Annex 12 #2.6.4

Camera Monitor arrangement

First proposal for location of the different display areas

Monitor Arrangement

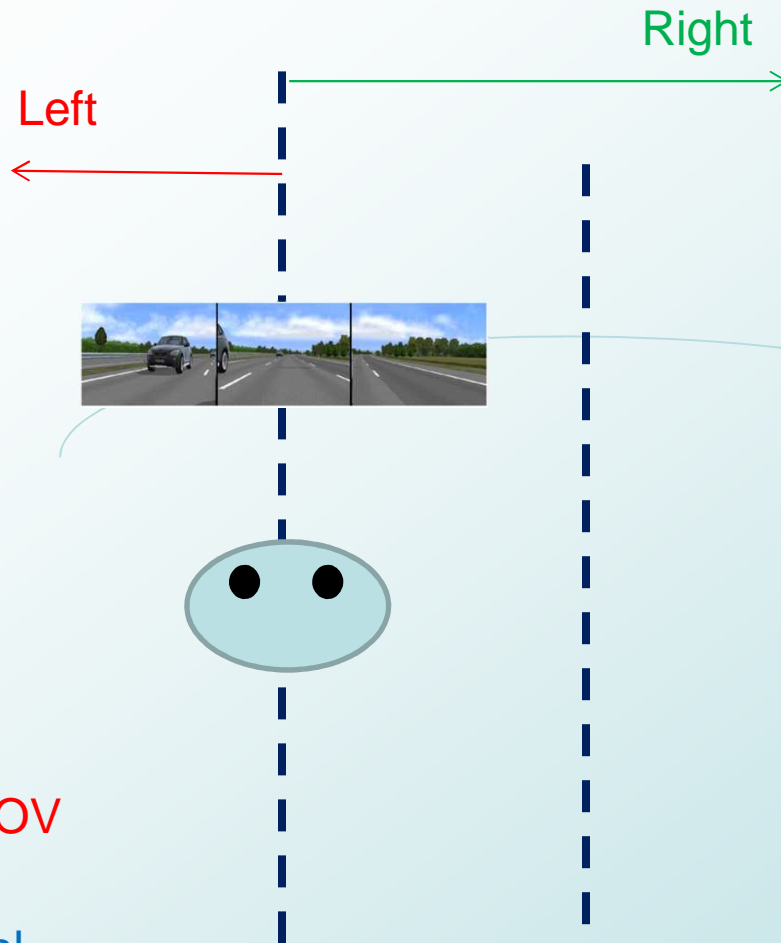
ALLOWED

Not recommended
« What is in front of the driver should be dedicated to forward driving informations »

Monitor Arrangement

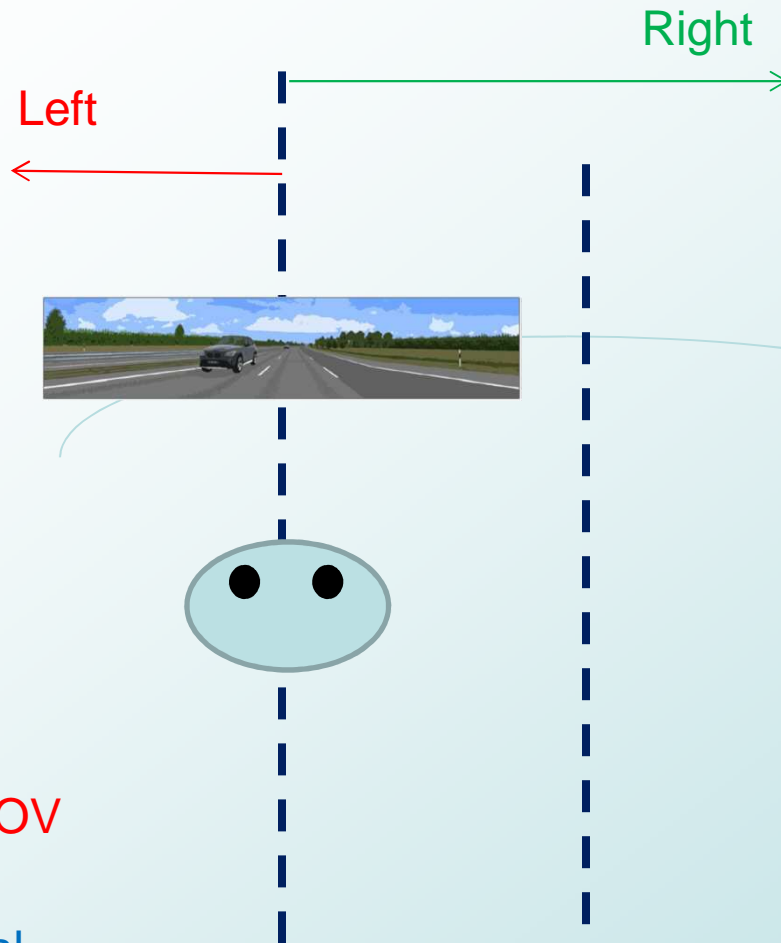
ALLOWED

Not recommended
« What is in front of the driver should be dedicated to forward driving informations »

Monitor Arrangement

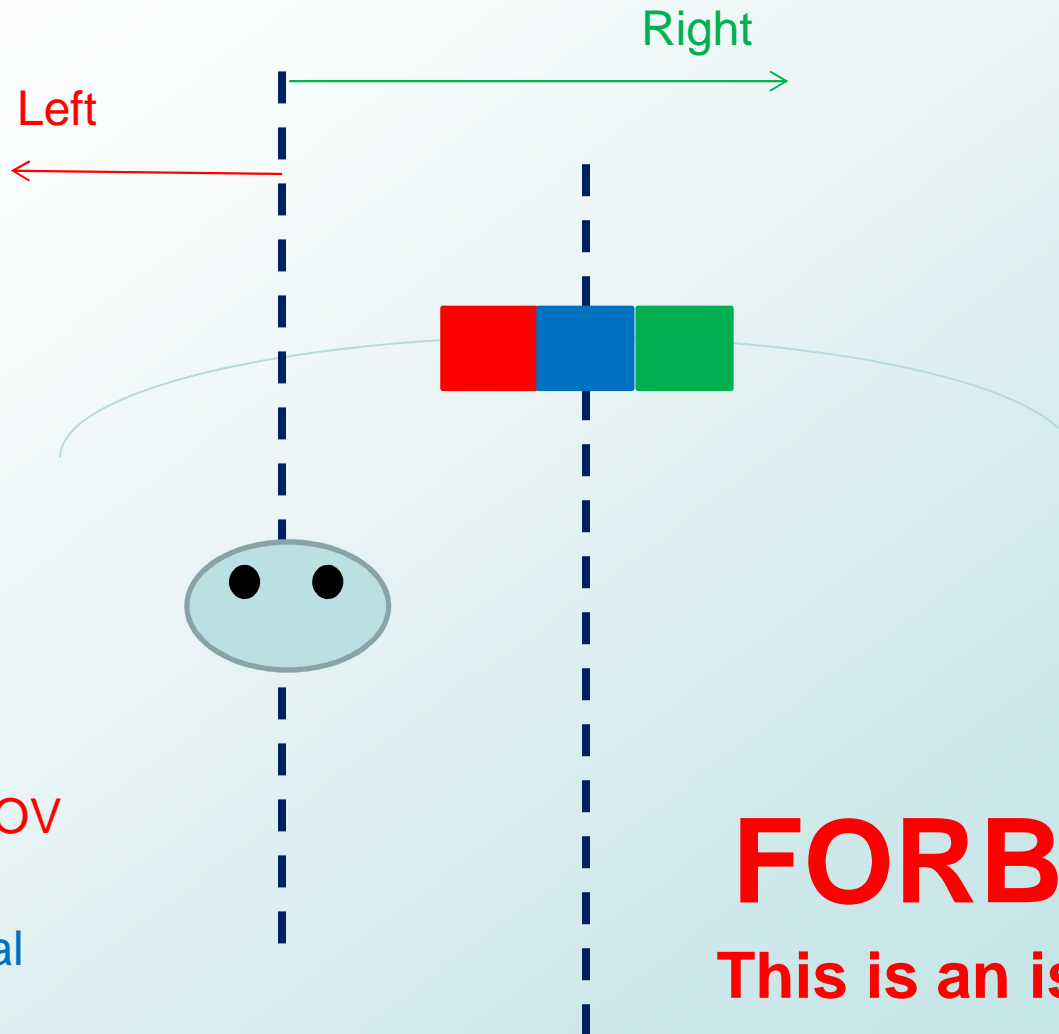
ALLOWED

Not recommended

« What is in front of the driver should be dedicated to forward driving informations »

Monitor Arrangement

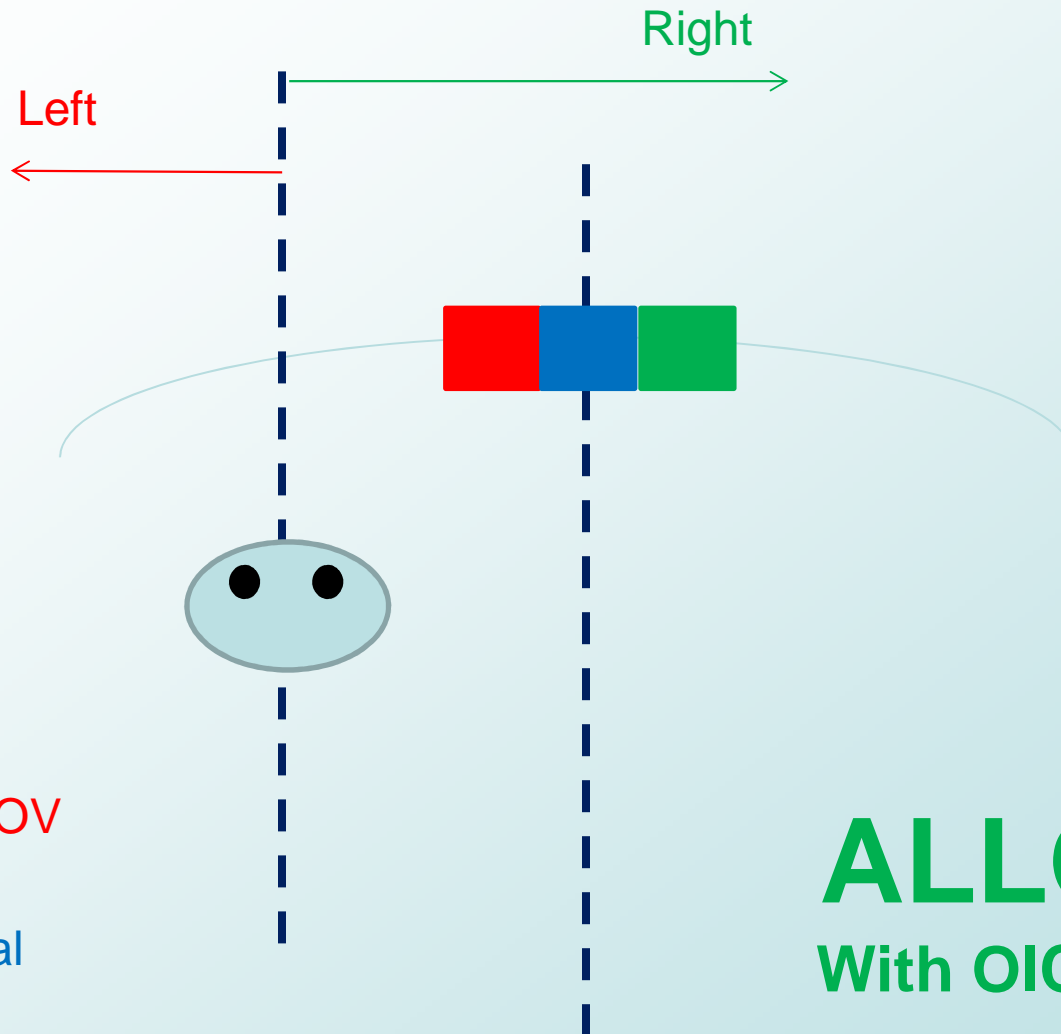
FORBIDDEN
This is an issue for OICA

OICA proposal

“The arrangement of the monitor(s) inside the vehicle shall be in such a way as expected by a driver.

This means, that the image of the **right side field of view shall be presented to the right of the longitudinal vertical plane passing through **the ocular reference point**, defined in paragraph 12.1. The image of the **left** side field of view shall be presented to the left of the longitudinal vertical plane passing through **the ocular reference point**.**

Notwithstanding the above requirements, in case where the three fields of view are shown on one display , the central axis of the latter may be located between the longitudinal vertical plane passing through the ocular reference point and the median longitudinal plane of the vehicle.

If the CMS shows more than one FOV on one display, non-continuous images shall be clearly separated from each other.”

Monitor Arrangement

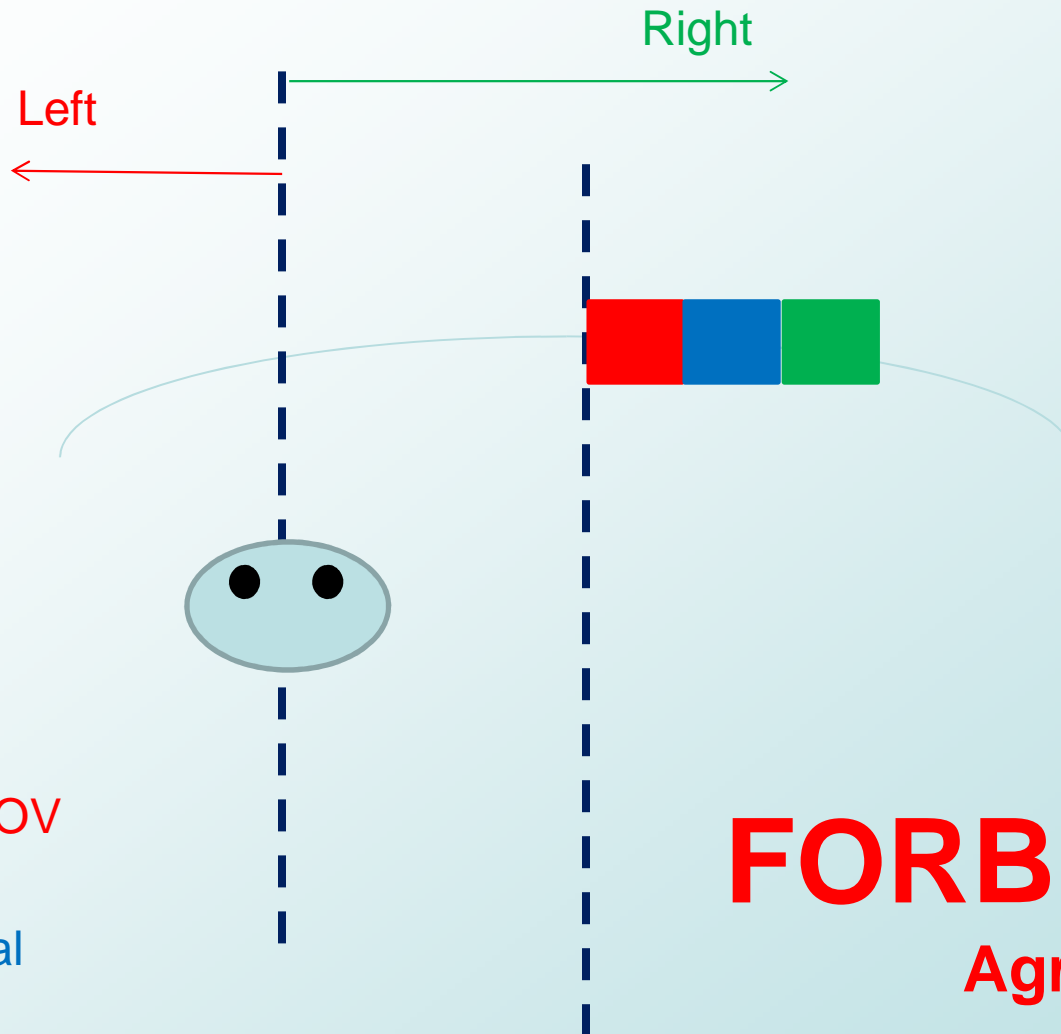
ALLOWED
With OICA proposal

OICA 2nd proposal with the 1st proposal

“The arrangement of the monitor(s) inside the vehicle shall be in such a way as expected by a driver.

This means, *for a left hand drive vehicle*, that the image of the right side field of view shall be presented to the right of the longitudinal vertical plane passing through the ocular reference point, defined in paragraph 12.1. The image of the left side field of view shall be presented to the left of the longitudinal vertical plane passing through the ocular reference point.

Notwithstanding the above requirements, in case where the three fields of view are shown on one display , the central axis of the latter may be located between the longitudinal vertical plane passing through the ocular reference point and the median longitudinal plane of the vehicle.

If the CMS shows more than one FOV on one display, non-continuous images shall be clearly separated from each other.”

Monitor Arrangement

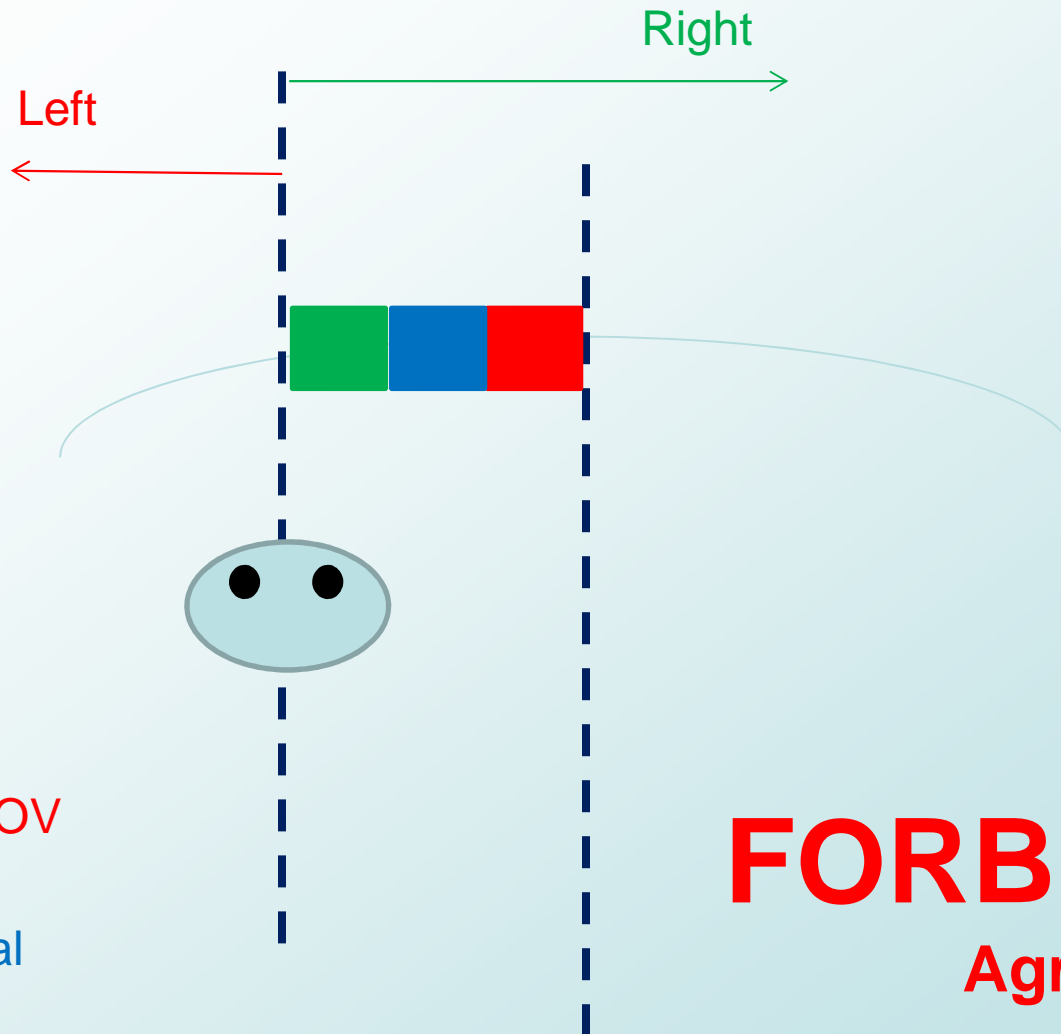
FORBIDDEN
Agreed
